Subject:
 Request for additional information correspondence dated June 16, 2015

Reference Docket No. 030-38784

PLUS, LLC Distribution License Application Clarification

Attachment 2 – Images of Container with Labeling

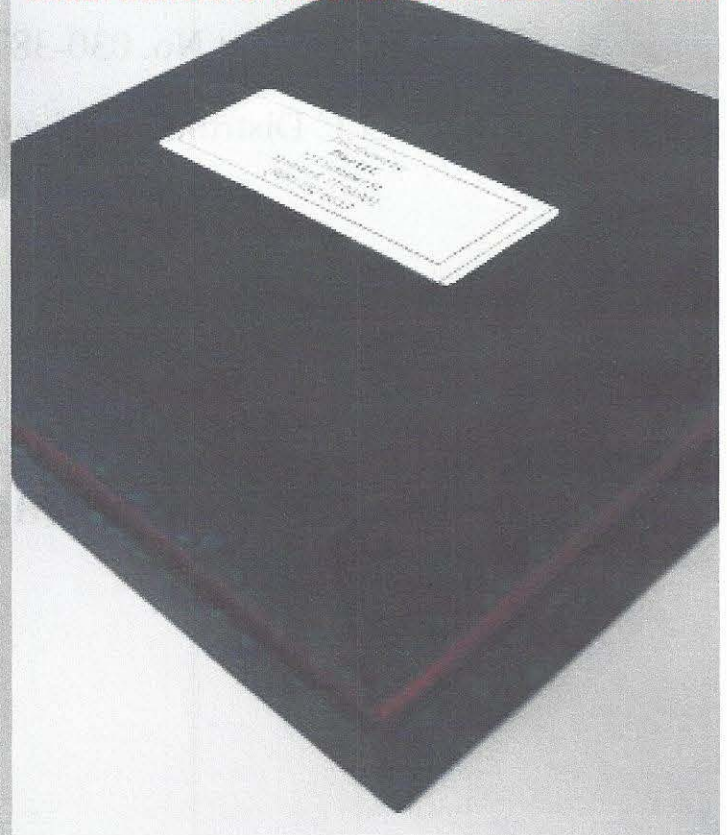
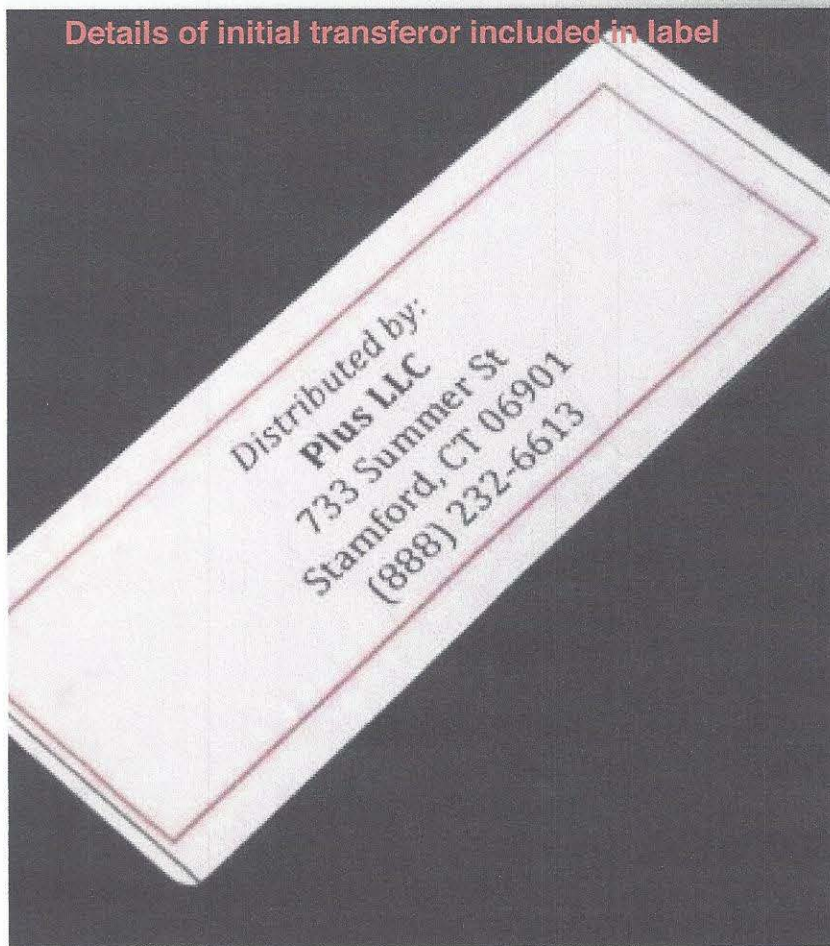
4. *"In your response letter mentioned above, item No. 3, you stated that manufacturer "Luminox" is noted on watch face. 10 CFR 32.14(b)(6) requires that labeling or marking its container with the identification of the manufacturer or initial transferor of the product and the byproduct material in the product."*

Since Plus LLC is the initial transferor, the labeling of the container will need to identify the initial transferor. Please submit a proposed label for the container (e.g. Drawing, imaging)."

PLUS, LLC will apply a label to the packaging container of the watch. The watch itself is clearly labeled as 'LUMINOX'. Please see attachment two for a visual example of the labeling of the package. The labeling of the watch itself can be identified in attachment one.

Initial transferor label on other side of container

Details of initial transferor included in label
